ORIGINATION FORM

Proposed Revisions to a Standard Plans Index
(Please provide all information — Incomplete forms will be returned)

Index Number: 700-010
Sheet Number (s): 4 of 10
Index Title: Single Column Ground Signs

Sheet 4: Changed NOTE 1 from "Class I" to "Class II".

SLIP BASE AND FOUNDATION DETAILS

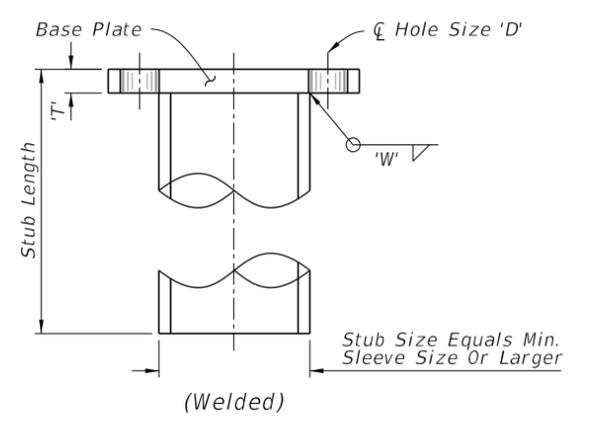
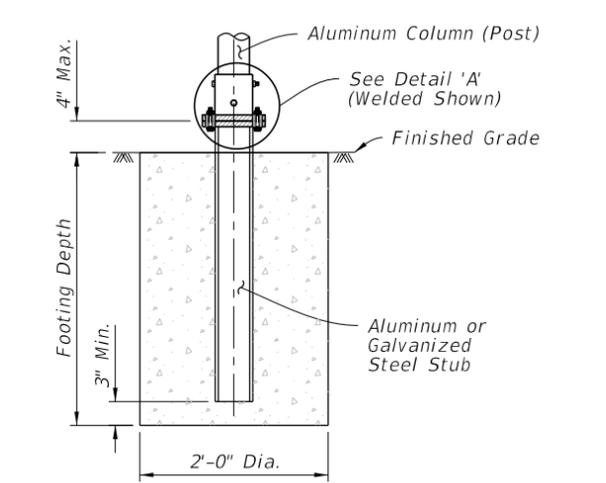
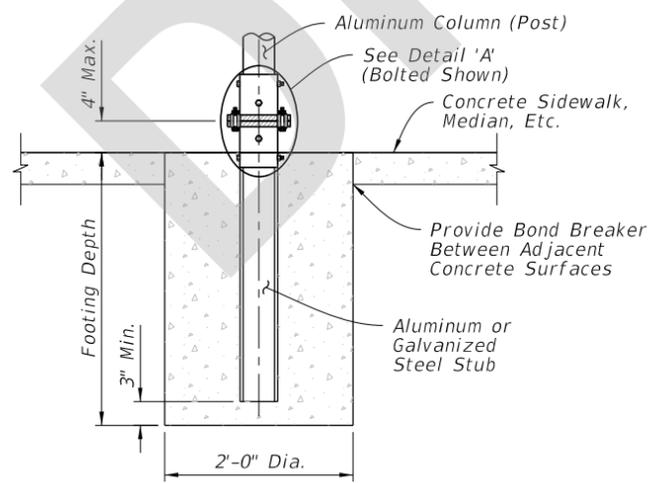
Changed to reflect Materials specification change that removes the designation for Class I Concrete.
Please see the attached Standard Specification Section 346 DRAFT for the Class I revisions proposed by the State Materials Office.

- Foundation Notes for Slip Base:
 - Place Stub into concrete foundation given in the FOUNDATION TABLE using Class II Concrete.
- Slip Base Fabrication Notes:
